Service Bulletin

Bulletin No: 01-03A

Product Line: ATV

Subject: Clutch Plenum Vent Boot

Fig. 1

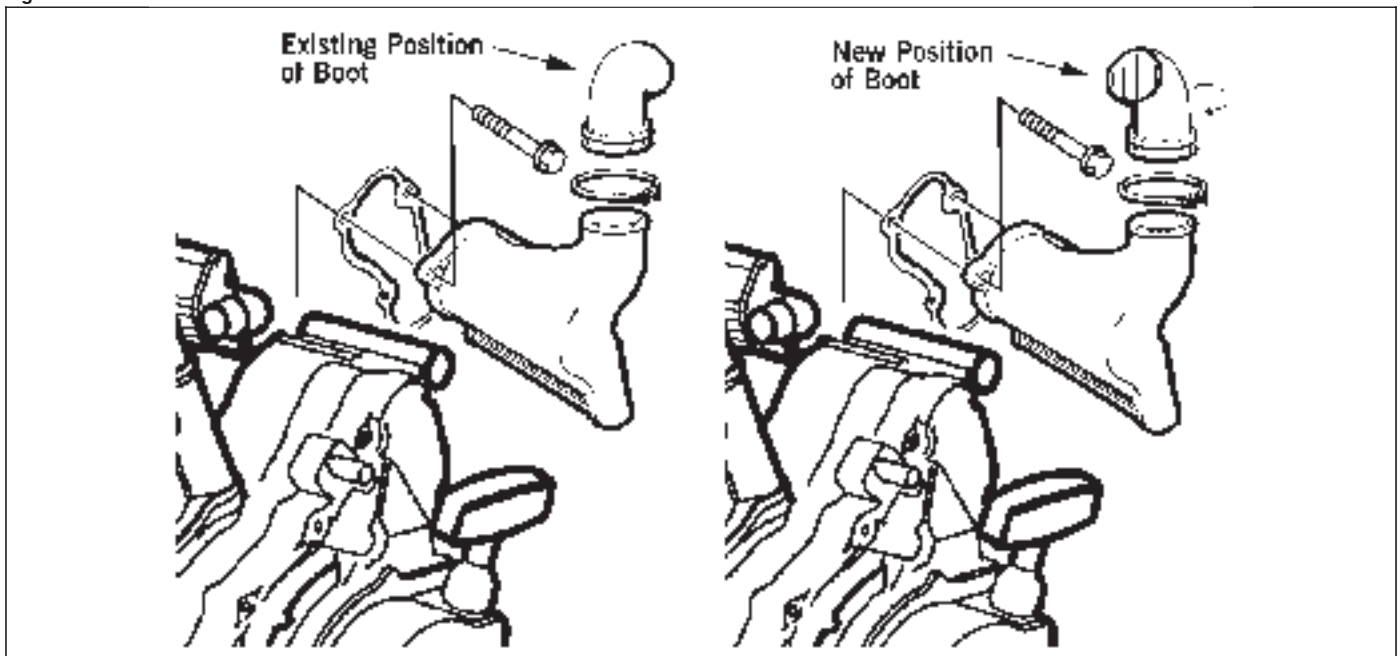
Condition: It has been determined that when the affected ATV's are ridden through shallow water at moderate to high speeds, the rear tires may cause water to enter the rear clutch plenum vent boot and then flow downward into the clutch housing.

Solution: Loosen the clamp securing the existing clutch plenum vent boot; then rotate the boot until the open end of the boot faces forward. See Fig. 1. Secure the boot with the existing clamp.
